HAMBLEN COUNTY LEGISLATIVE BODY

Regularly Scheduled Monthly Meeting
Thursday, October 19, 2023
5:00 p.m.

Project Name	Arch Project No.	Date
Hamblen County Justice Center	**590418**	**3/8/2023**
Subject	Specification No.	Drawing No.
RFI-204 and RFI-204.1 Exit Sign Deletions Day Rooms	**NA**	E2.1A.1, E2.1AM.1, E2.1B.1, E2.1BM.1, E2.2A.1, E2.2AM.1, E2.2B.1, E2.2BM.1, E2.3A.1, E2.3B1, AA5.1.7, A6.1.5.

1 SITE PLAN - ELECTRICAL

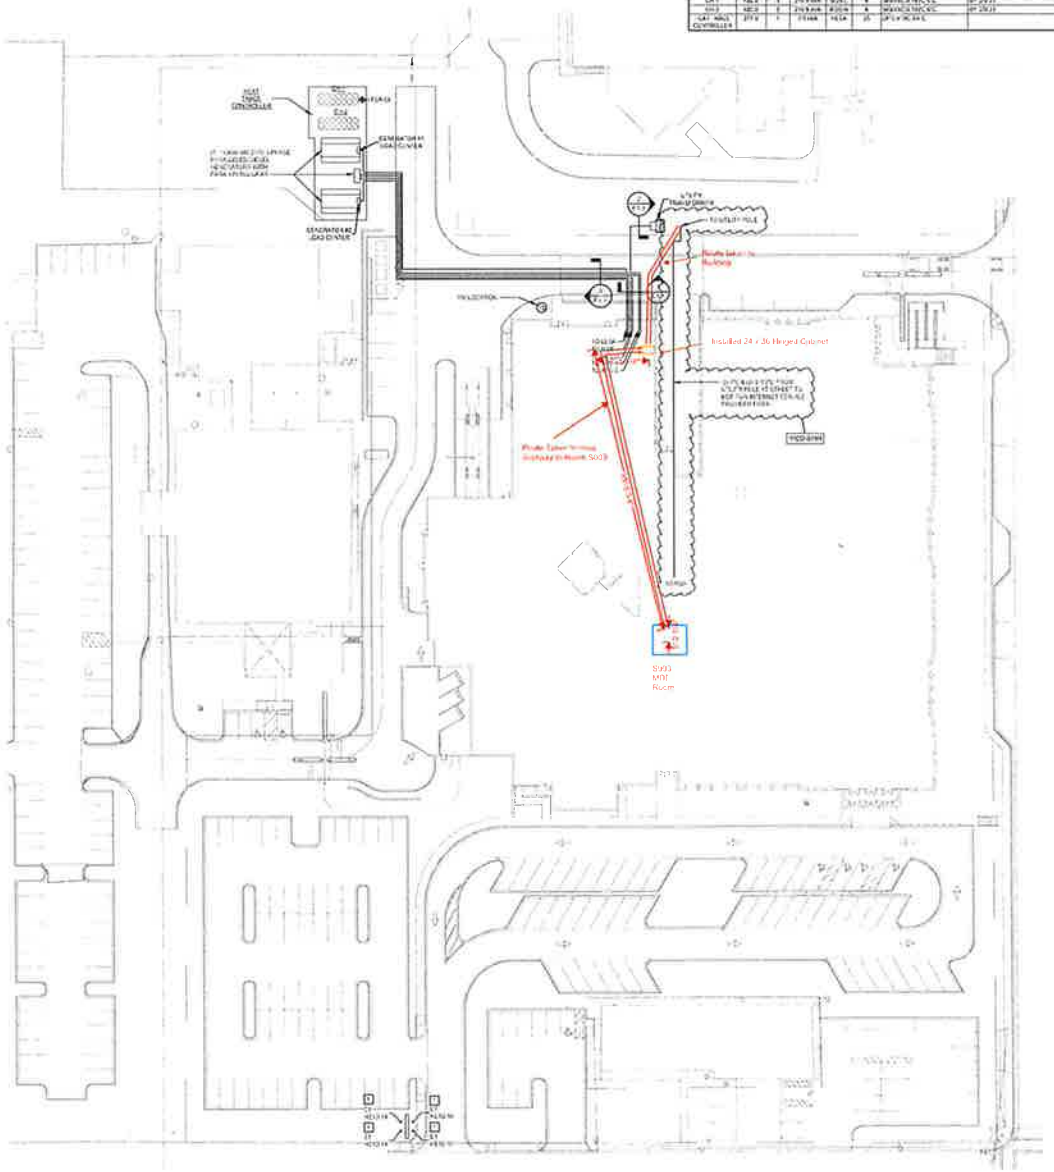
Project Name	Arch Project No.	Date
Hamblen County Justice Center	**590418**	**4/19/2023**
Subject	Specification No.	Drawing No.
Communications	**NA**	**E1.1**

Please refer to updated drawing E1.1 showing coordination for underground conduit indicated in original PCO-049 to turn up at the utility pole closest to the transformer.

FLOOR PLAN - LEVEL 1M - PART A - LIGHTING

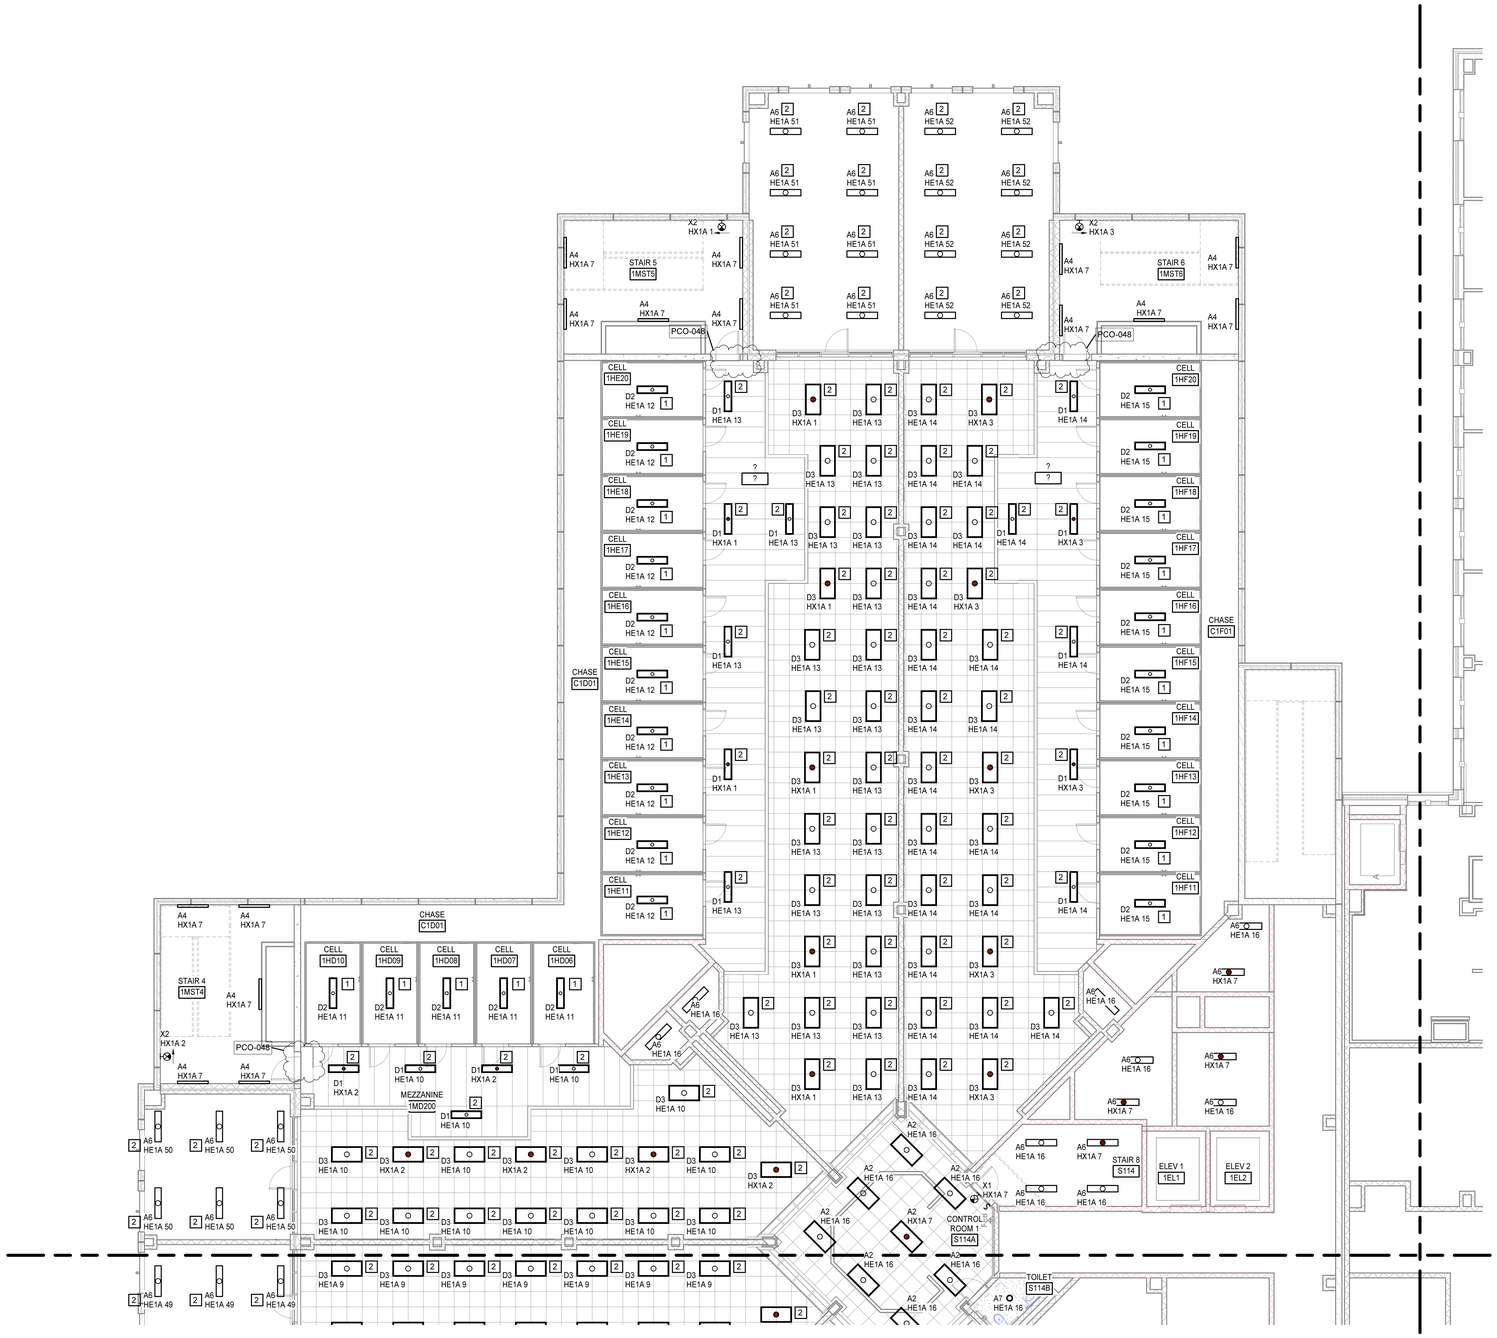
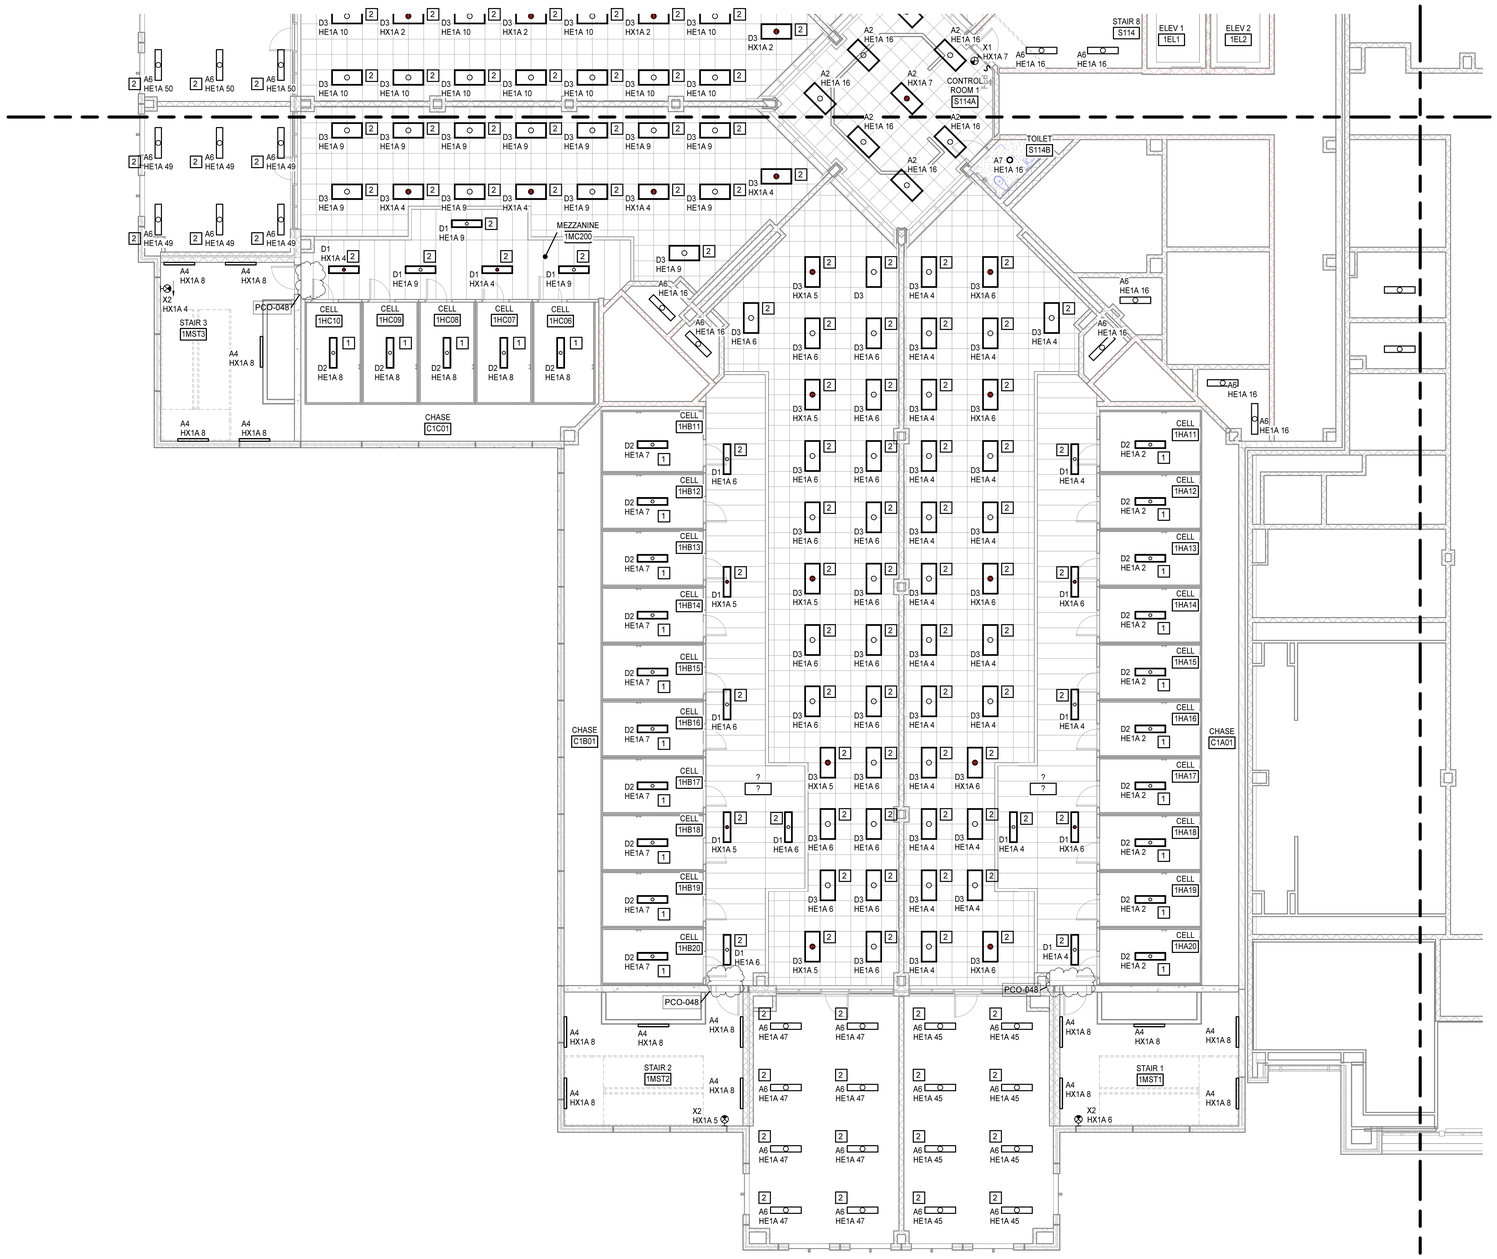
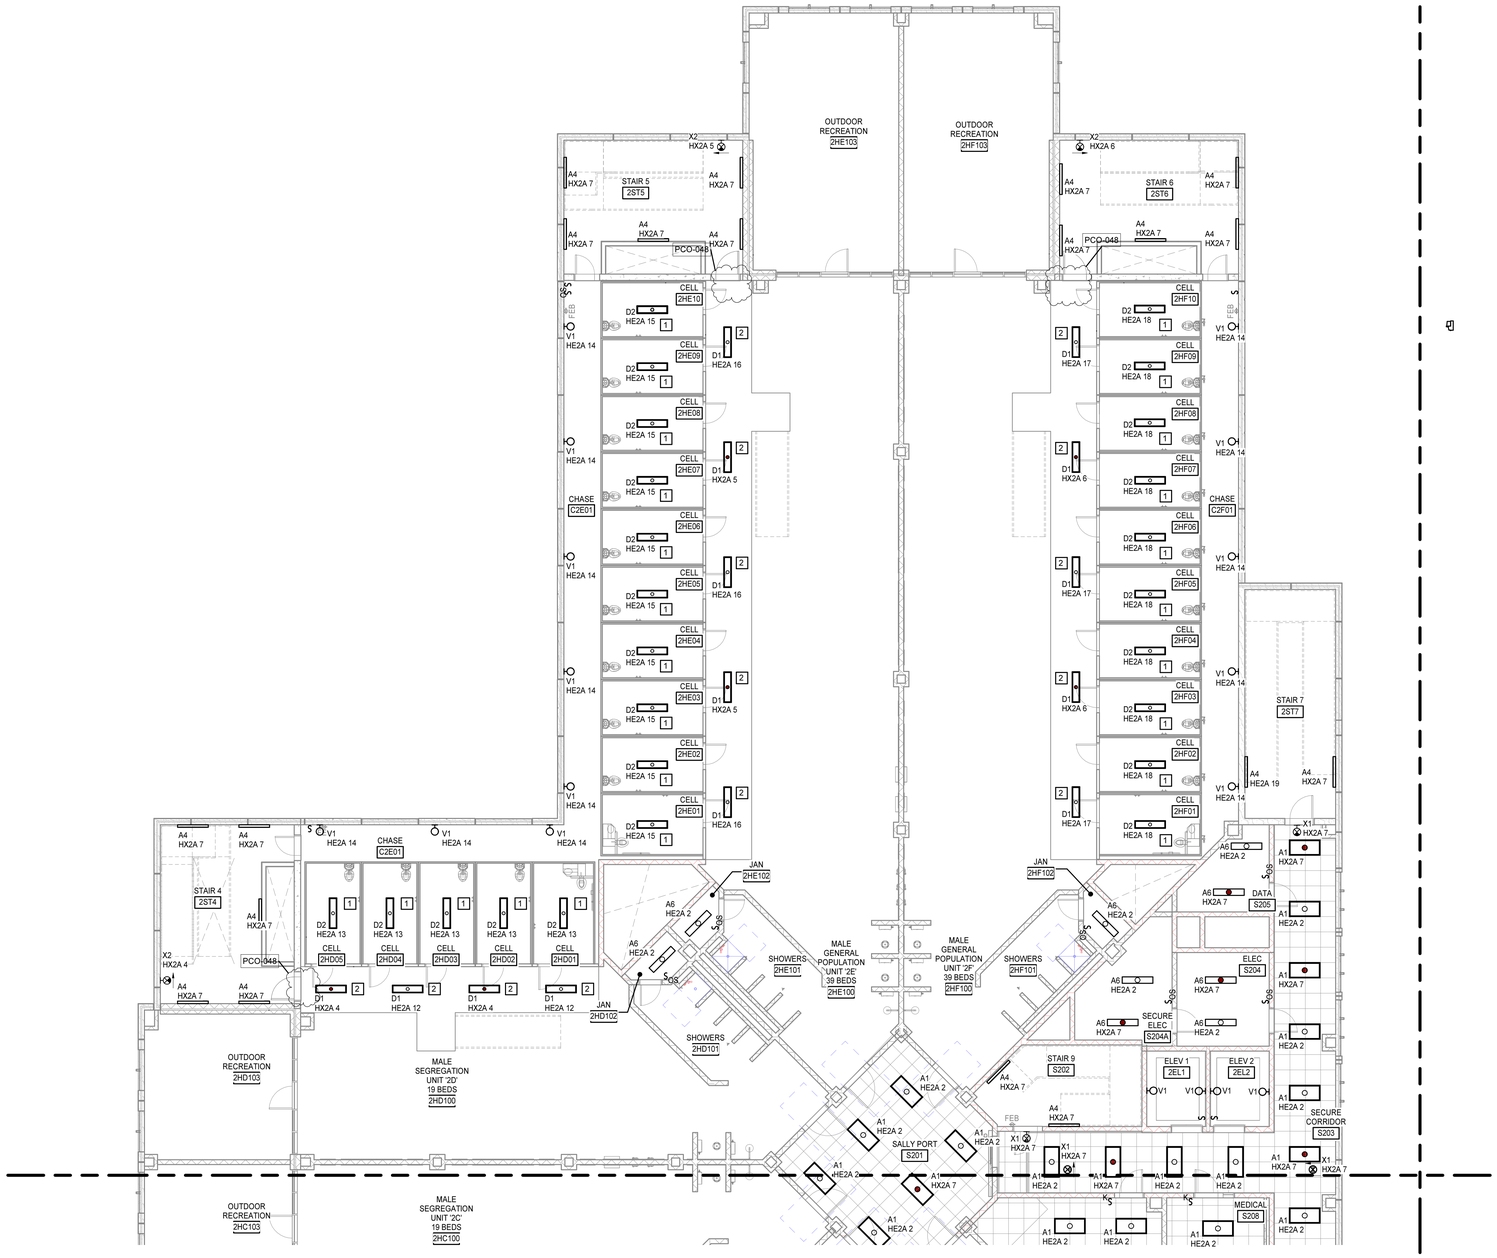
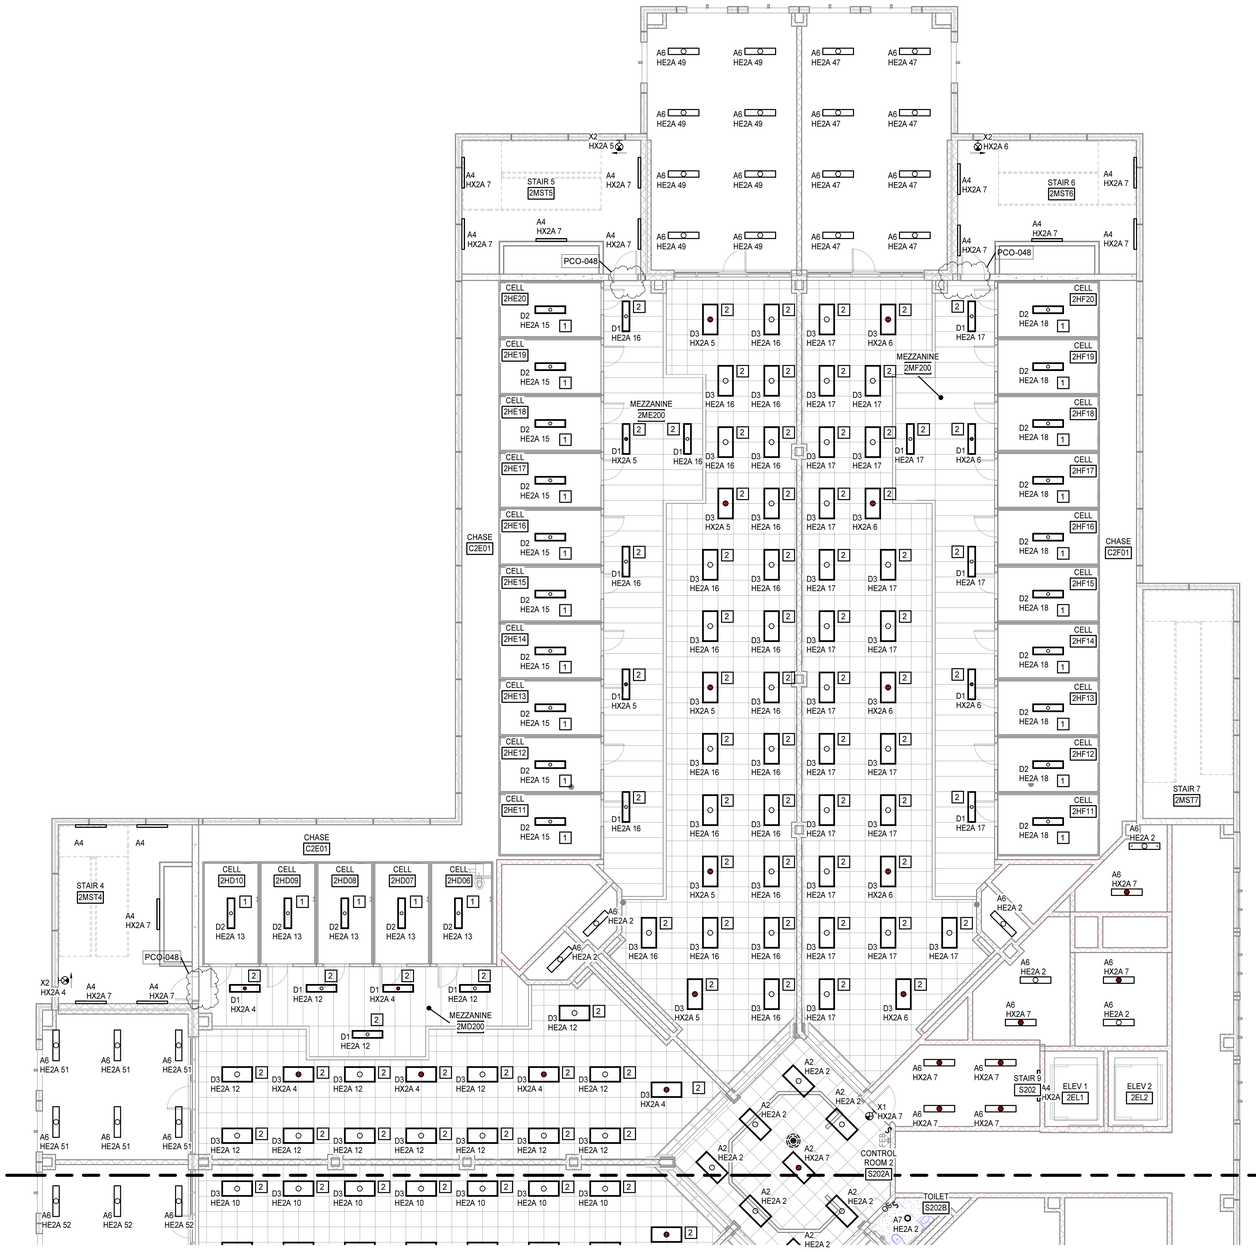
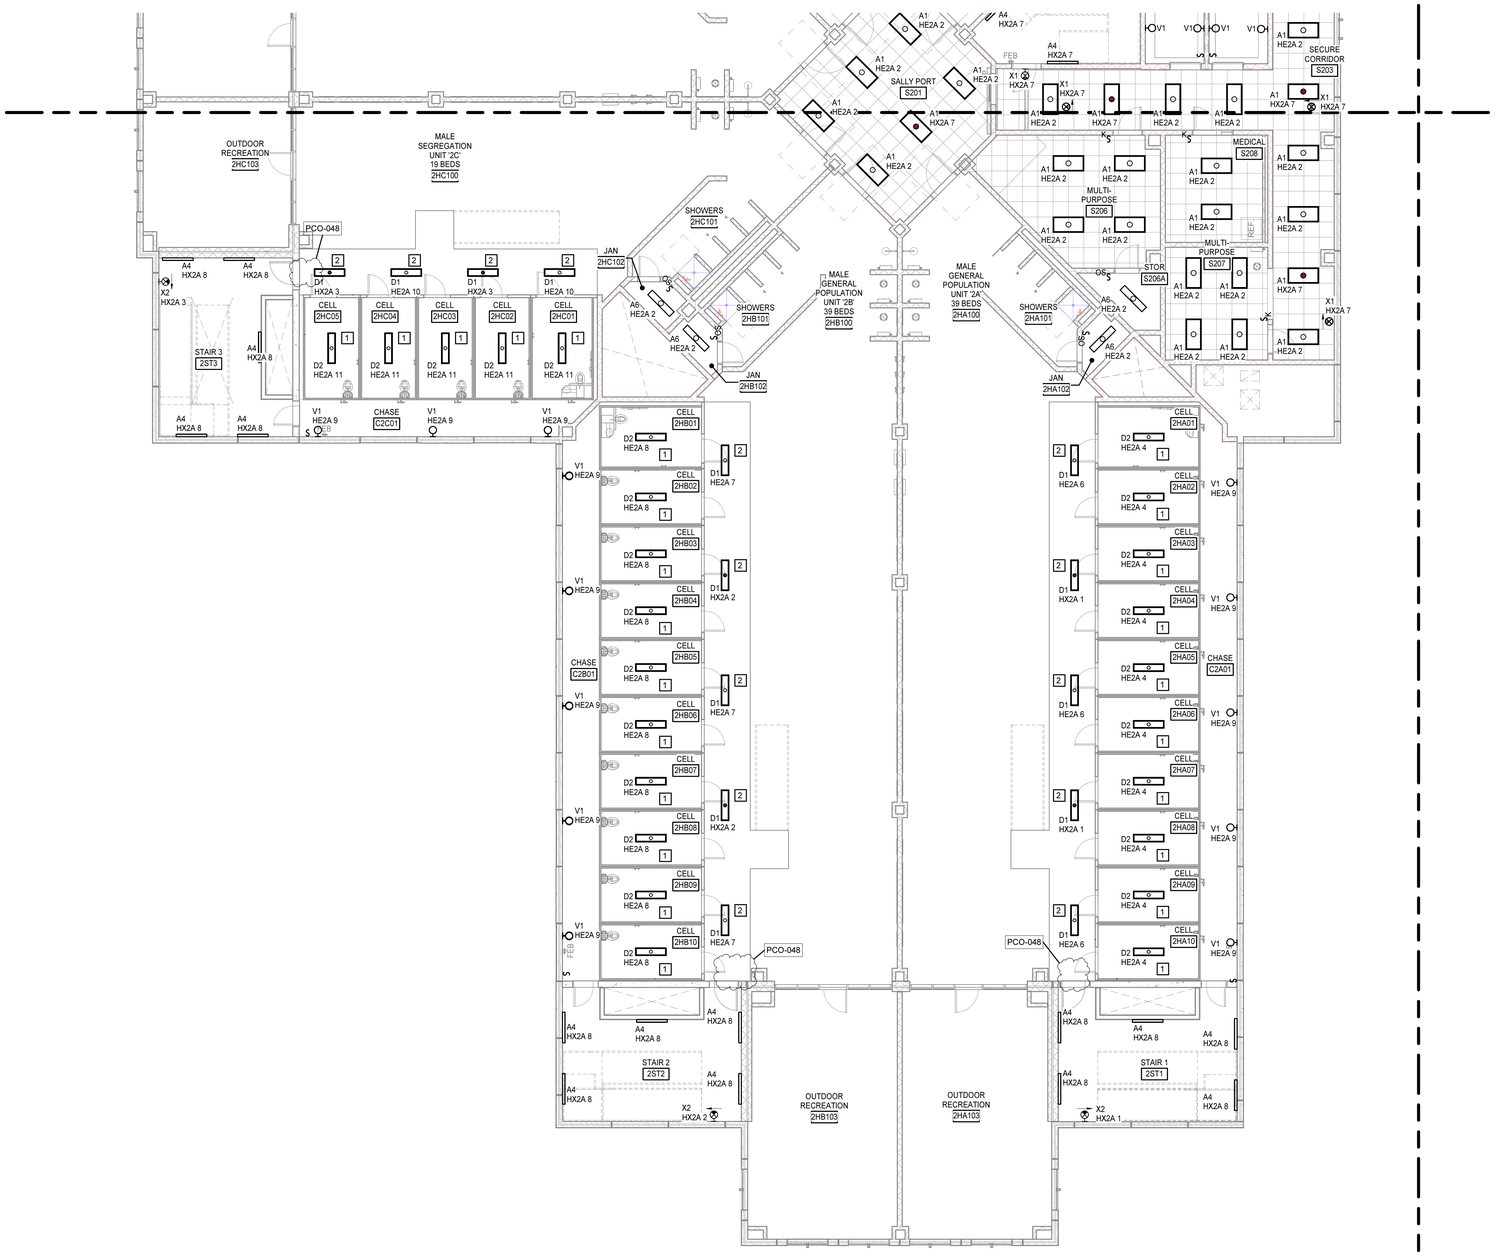
Please refer to updated drawings E2.1A.1, E2.1AM.1, E2.1B.1, E2.1BM.1, E2.2A.1, E2.2AM.1, E2.2B.1, E2.2BM.1, E2.3A.1, E2.3B1, AA5.1.7 and A6.1.5. These have been updated in response to RFI-204 and RFI-204.1. As discussed exit signs are not required in the day rooms. These updated drawings have been sent to state of TN for review and have been approved. The architectural drawing updates relate to deleting the note to provide a soffit for sprinkler pipe. The plate under mezzanine had been lowered to accommodate this change. Contractor is requested to hold it as high as possible.
